**ON-SITE SEWAGE DISPOSAL SYSTEM
HOWARD COUNTY HEALTH DEPARTMENT
BUREAU OF ENVIRONMENTAL HEALTH**

SUBDIVISION: Brantwood 3/1 LOT NUMBER: 7

ADDRESS: 3063 Seneca Chief Trail PROPERTY OWNER: NVR, Inc.

Title: REVISION 12 TO GPO2-34
BRANTWOOD 3/1 LOT 7

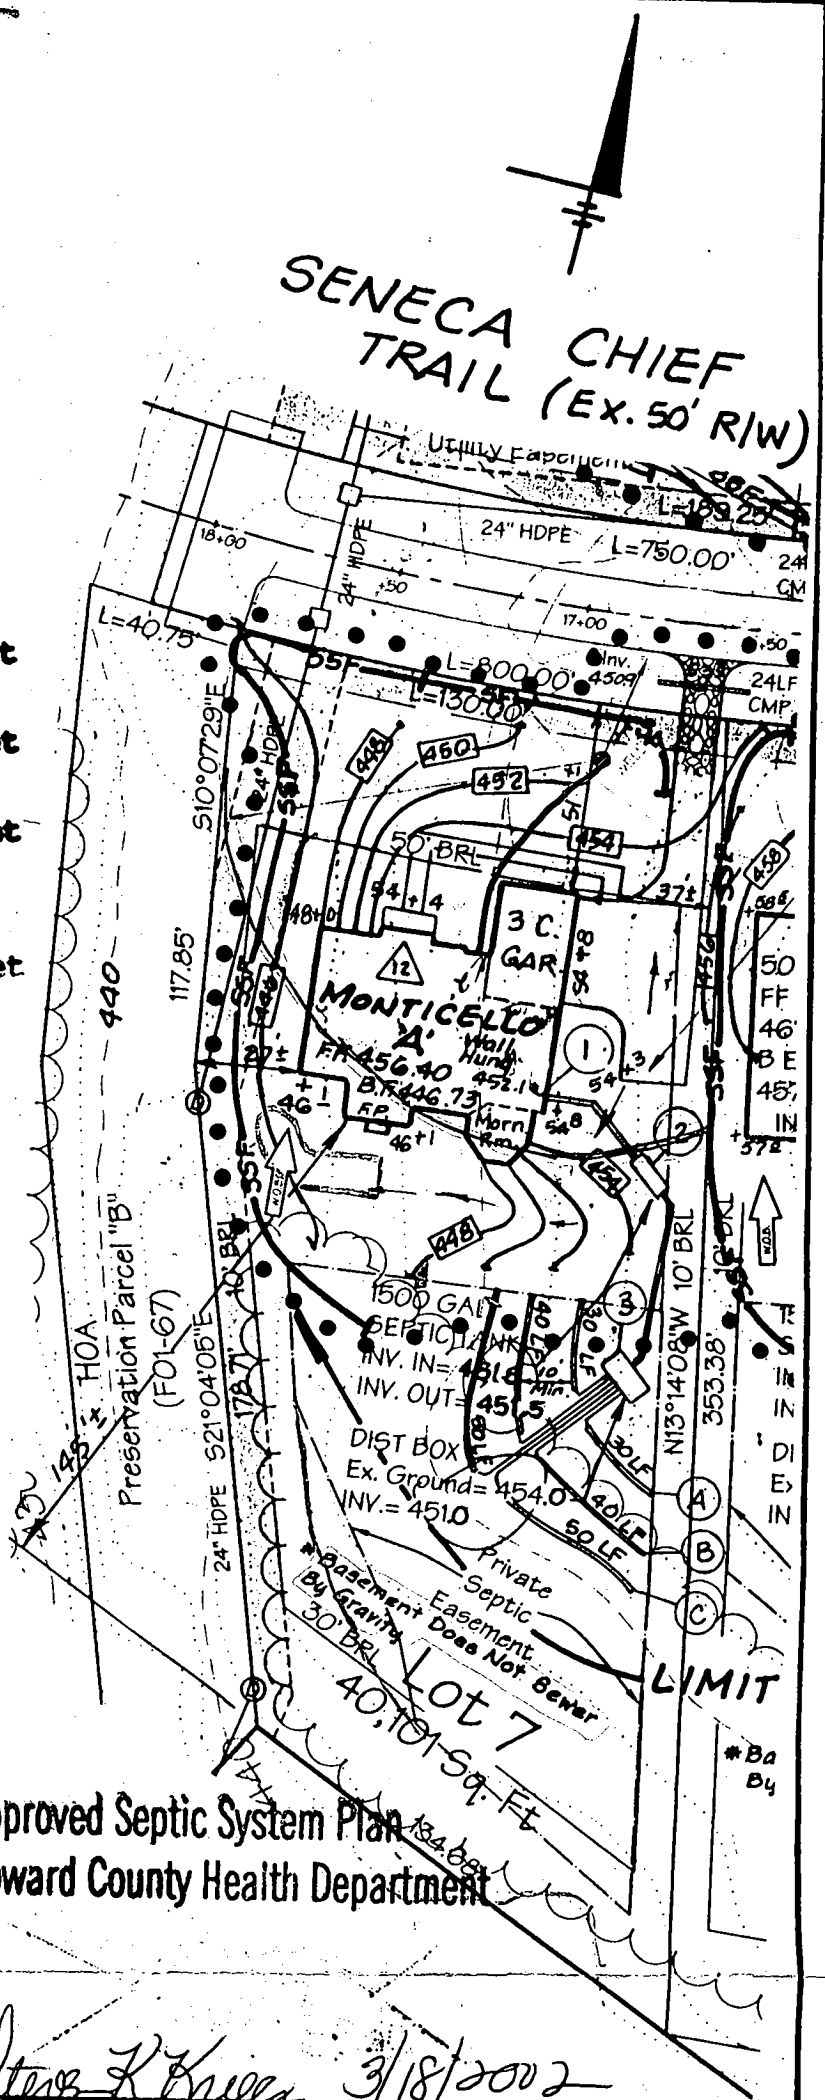
PRE-CONSTRUCTION 8/6/02 Lot staked, contour not as shown. OK to run 60' / 30' / 100' trenches on contour (S)

LOCATION DRAWING

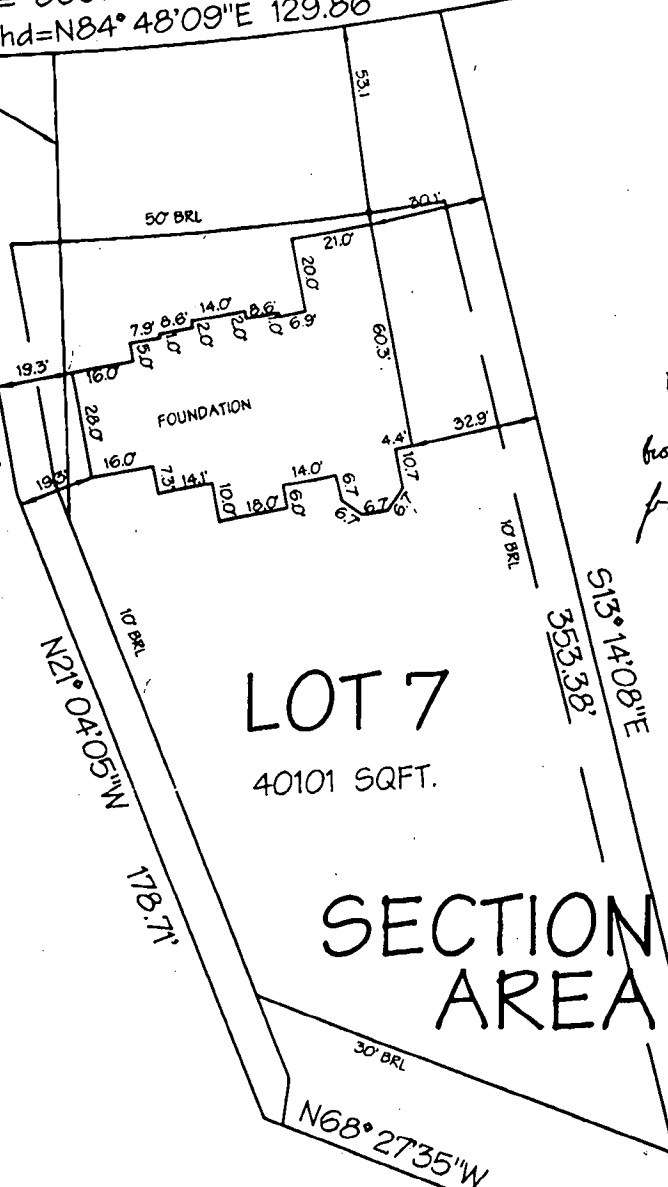
*Well check OK
Dimension are off on base width
but base appears to be far enough
from well + Septic
RJP 8/2/02*

PROPERTY KNOWN AS:
LOT 7
BRANTWOOD SEC 3 AREA 1
PLAT NO. 14876
HOWARD COUNTY, MD

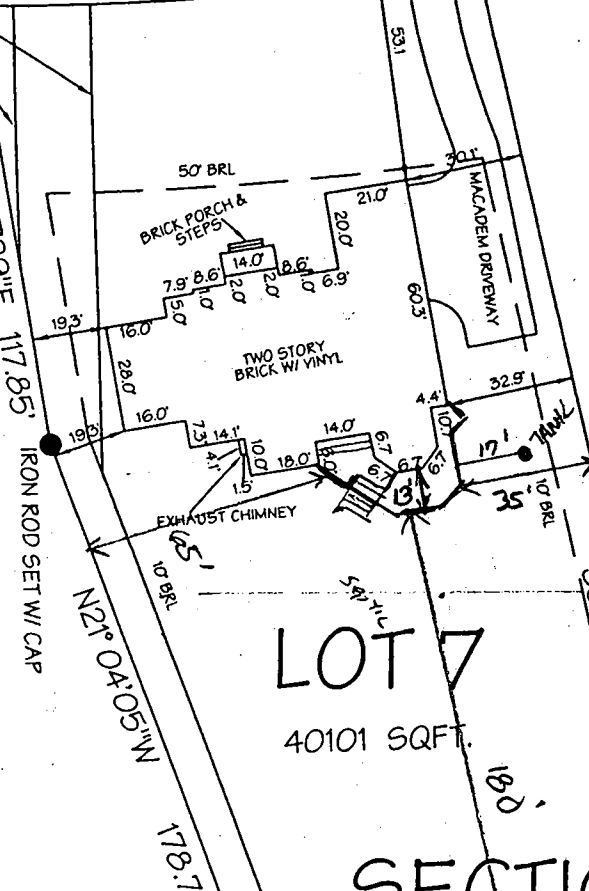
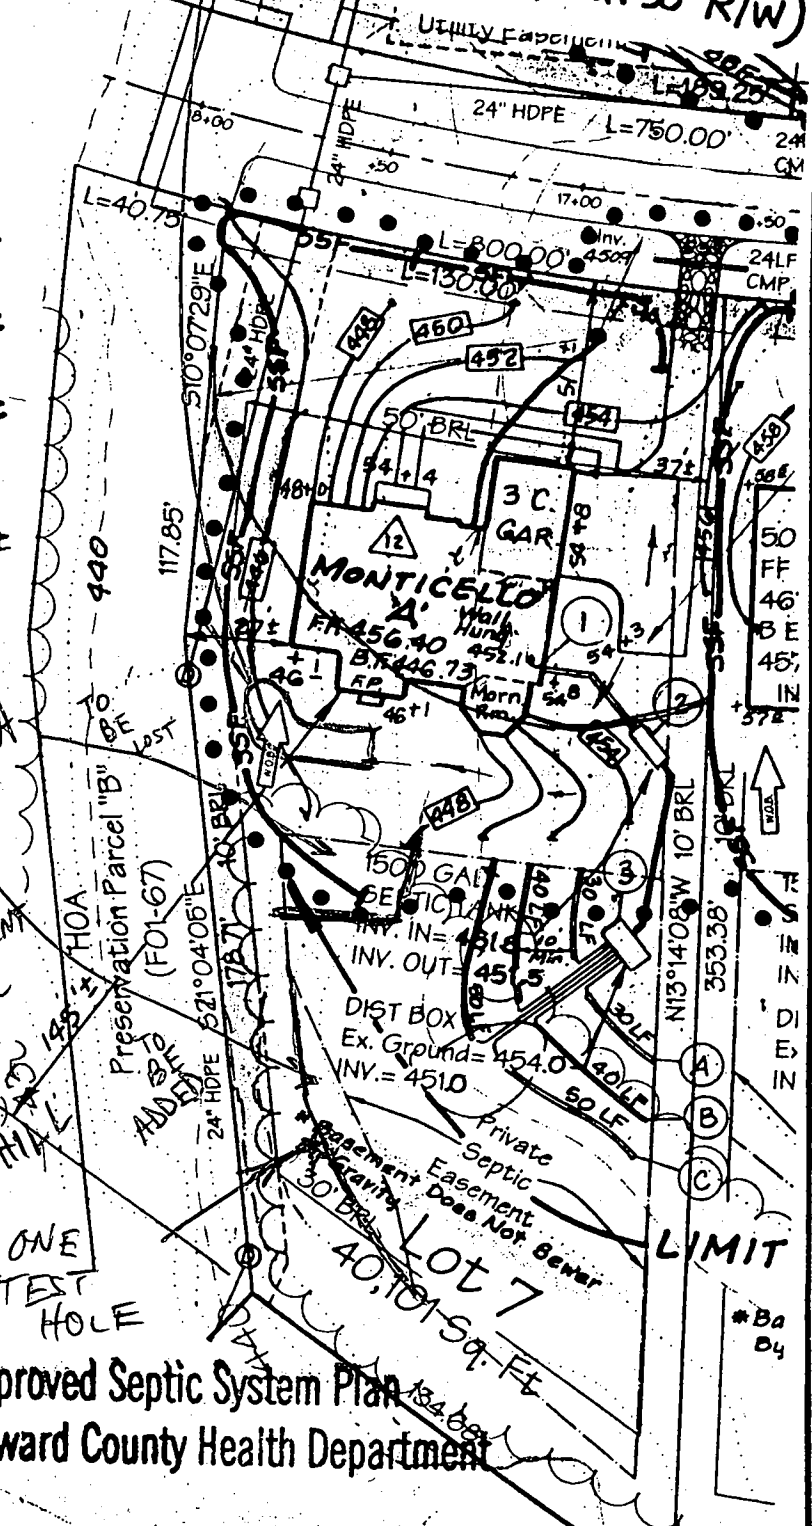
Proposed Deck O.K.

ONLY POOL POSS. W/O ADS.

POSS. ADS. (6000) CONTINGENT ON PERC SLOPES DOWNHILL

ONE TEST HOLE
